Sheringham Shoal and Dudgeon Offshore Wind Farm Extension Projects

The Applicant's Comments on Perenco UK Limited's Deadline 7 Submission

Document Reference: 22.32

Figure 1

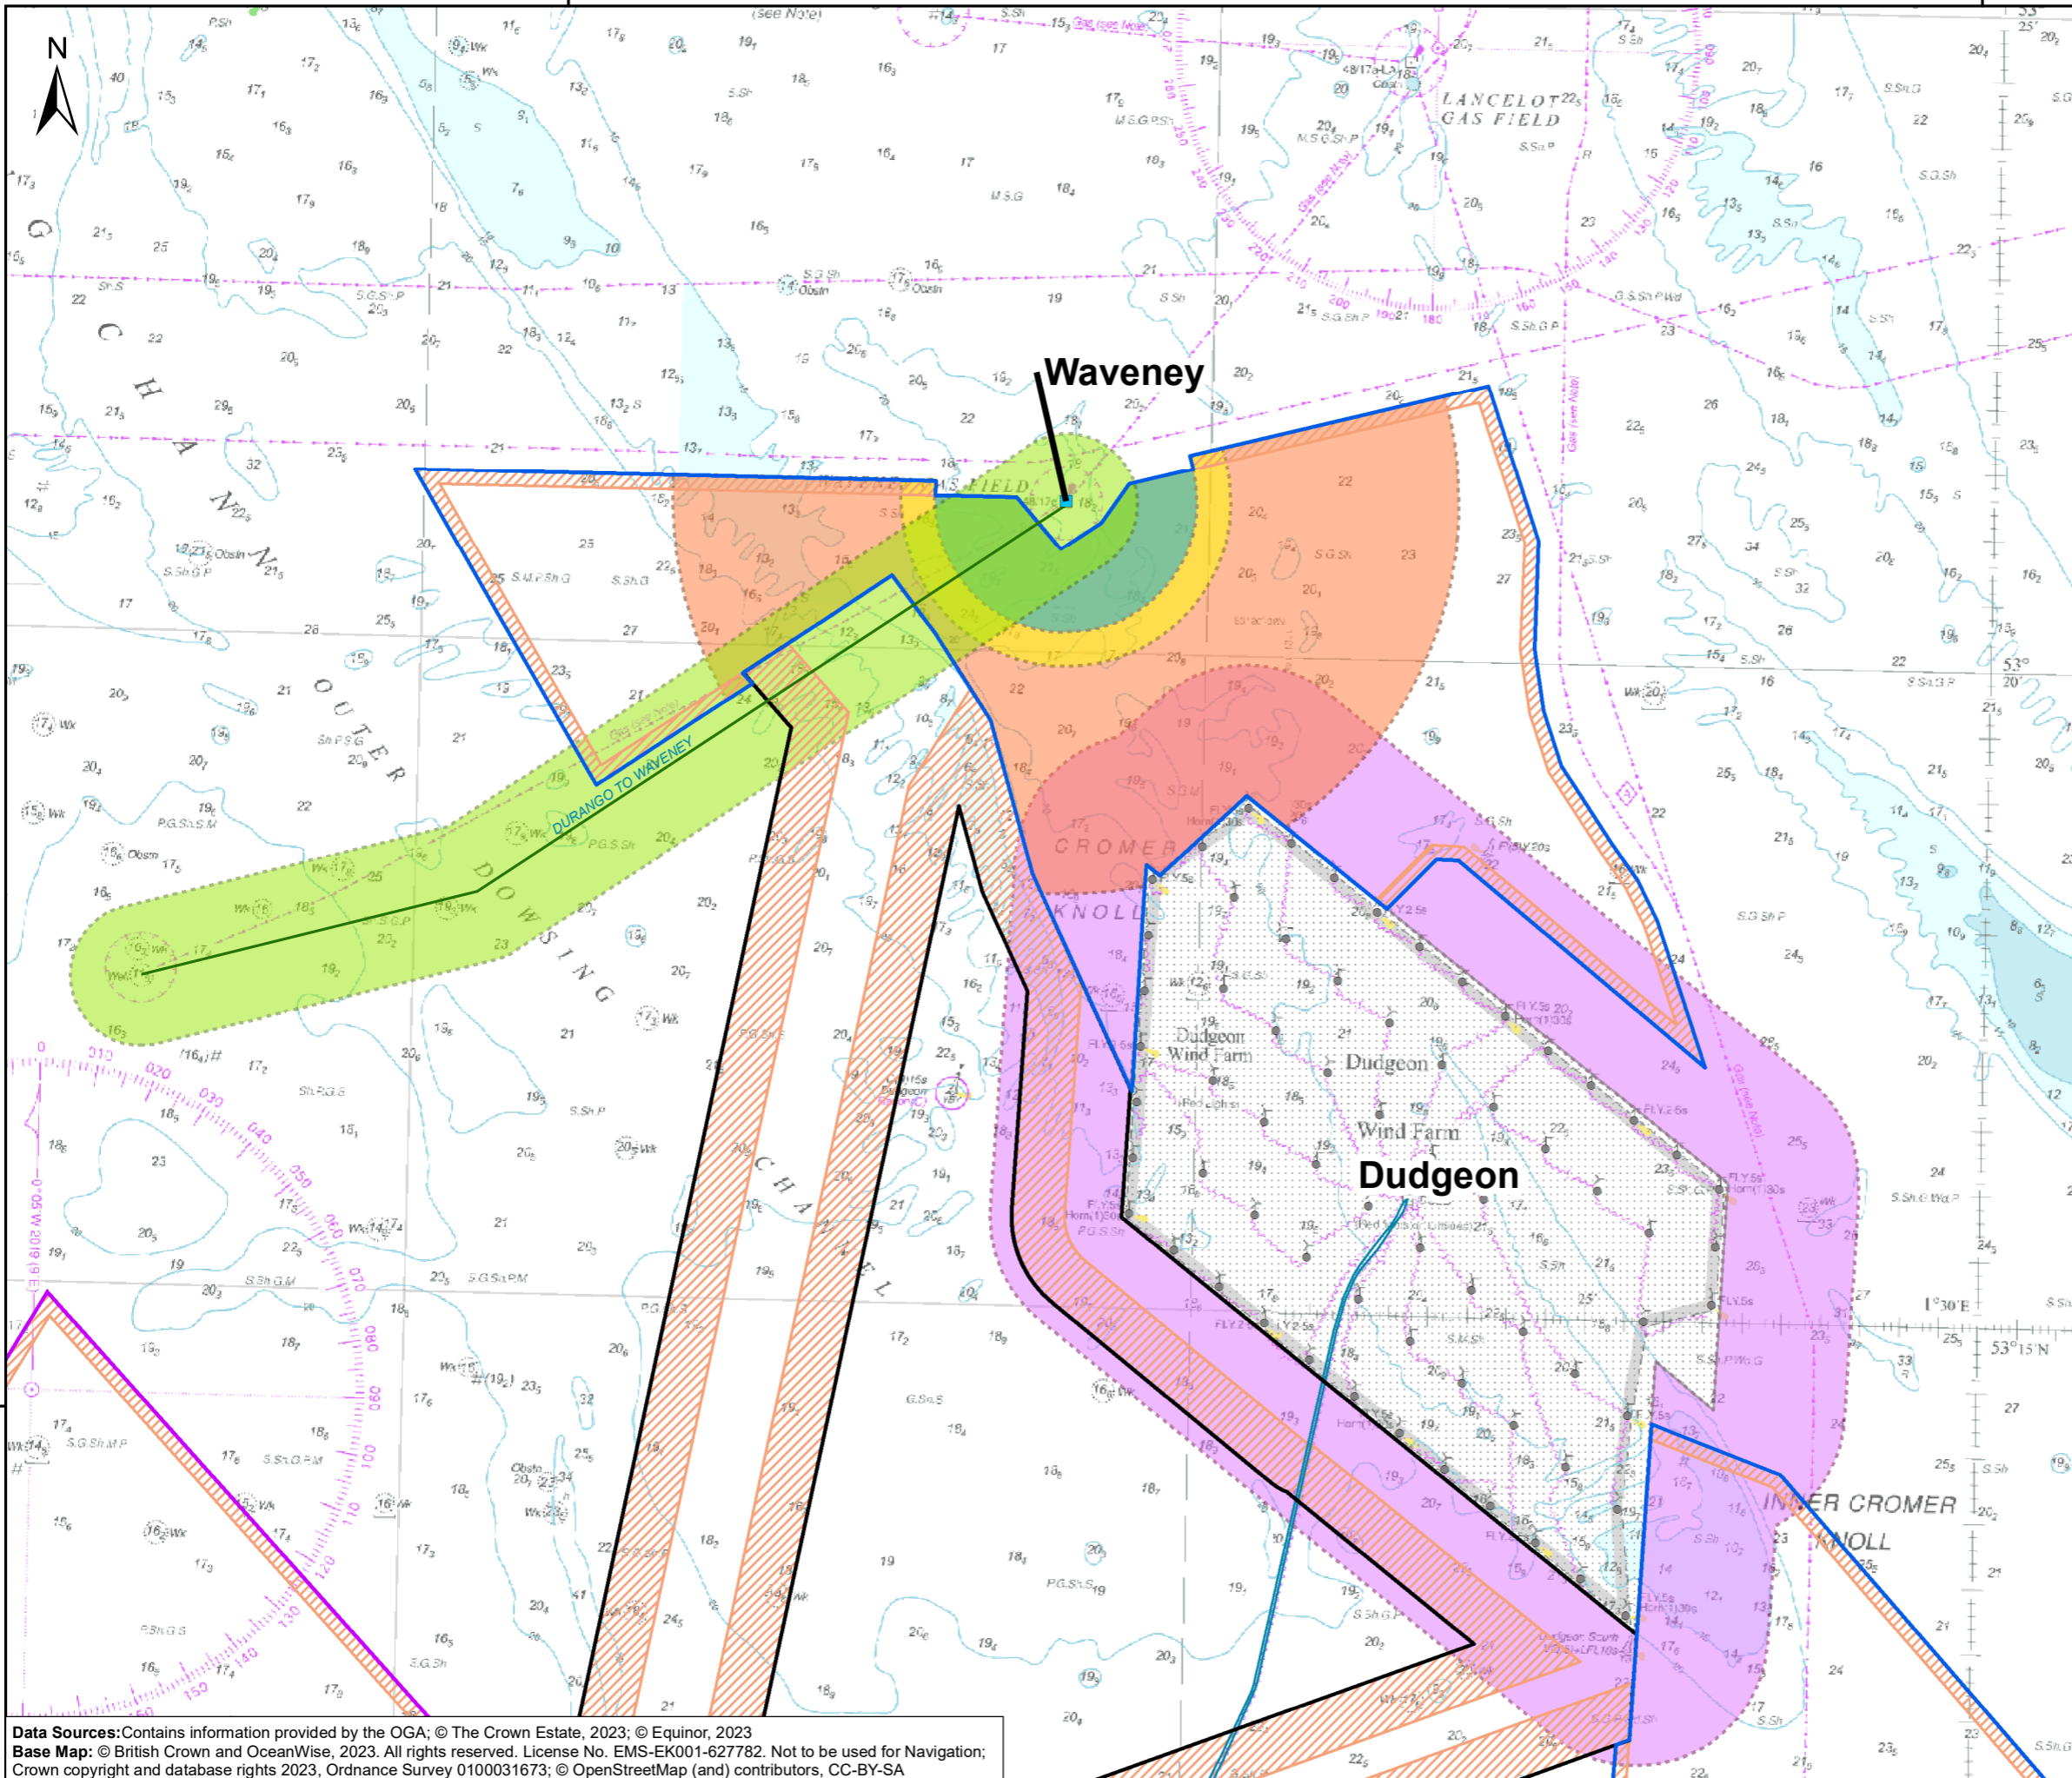
4.1 Compliance with National Policy Statement EN3		
5	<p>i. The proposed Development cannot be said to minimise negative impacts on other offshore infrastructure or activity. As has been demonstrated by both the Applicant and PNSL, negative impacts (loss of suitable periods in which flights may take place) increase as wind turbine rotor tips are placed closer to the installation with step changes at 3nm and 1.26nm (or in the Applicant's view 1.01nm). It is PNSL's view that a minimum distance of 3nm is required to minimise the negative impact on the Waveney Installation and the ability to decommission the Durango Well. However, as Mr Sanders stated in ISH7, PNSL would be amenable to a commercial arrangement which provides compensation for economic losses (arising from a level of negative impacts) for a minimum distance of 1.26nm which could meet the requirement to minimise negative impacts.</p>	<p>NPS EN3 (2.6.183) states that the decision maker should employ a 'pragmatic approach' in these situations and should expect the '<i>applicant to minimize negative impacts and reduce risks to as low as reasonably practicable</i>'. In recognition of this, the Applicant has entered into extensive engagement with Perenco to resolve their concerns. The Applicant notes that when it consulted at PEIR stage, it proposed an initial buffer of 500m which it subsequently increased to 1.nm upon submission of the DCO application (as shown on the Works Plans (Offshore) (Revision D) [document reference 2.7]) and most recently to 1.26nm through the Protective Provisions included at Part 15 of Schedule 14 of the draft DCO (Revision K) [document reference 3.1], which has all been achieved through ongoing discussions with Perenco and expert engagement.</p> <p>The application of a 1.26nm buffer further mitigates the potential negative impacts on Perenco by reducing risks to as low as reasonably practicable. Increasing the buffer any further, whether that be 1.5nm or 3nm would make no material difference to % of available access time as IMC flights would still be lost; but it would have an unacceptable detrimental impact on the area available for the development of DEP-N, fundamentally affecting the viability of DEP (as shown in Figure 1 of this document). Both parties agree that beyond 1.26nm that IMC access is lost and there is no mitigation for this through turbine layout (see Appendix A.7 of Supporting Documents for the Applicant's Responses to the Examining Authority's Fourth Written Questions [document reference 21.5.1]).</p> <p>Appropriate mitigation to minimise disruption and economic loss is secured by the inclusion of a 1.26nm buffer in the Protective Provisions included within the draft DCO Part 15 of Schedule 14 of the draft DCO (Revision K) [document reference 3.1]. Whilst the Applicant will continue engaging with Perenco, a commercial agreement between Perenco and</p>

ID	Perenco Comment	Applicant Response
		<p>the Applicant prior to the close of examination is not necessary to reach the conclusion that the Applicant has complied with the relevant policy position set out in NPS EN-3.</p> <p>On this basis and as set out further below, the Applicant considers that the ExA can be satisfied that <i>“the site selection and site design of the proposed offshore wind farm has been made with a view to avoiding or minimising disruption or economic loss or any adverse effect on safety to other offshore industries”</i> in accordance with paragraph 2.6.184 of NPS EN3 and can recommend consent and the SoS can equally grant consent on this basis. In considering this point the Applicant highlights the NPS EN-3 supports the pragmatic co-existence of offshore wind farms and oil and gas installations. The proposed 3nm distance advocated by Perenco is clearly at odds with this policy given the fundamental affect it has on the available area for turbines in the DEP-N area, and the viability of DEP (as shown in Figure 1 of this document).</p>
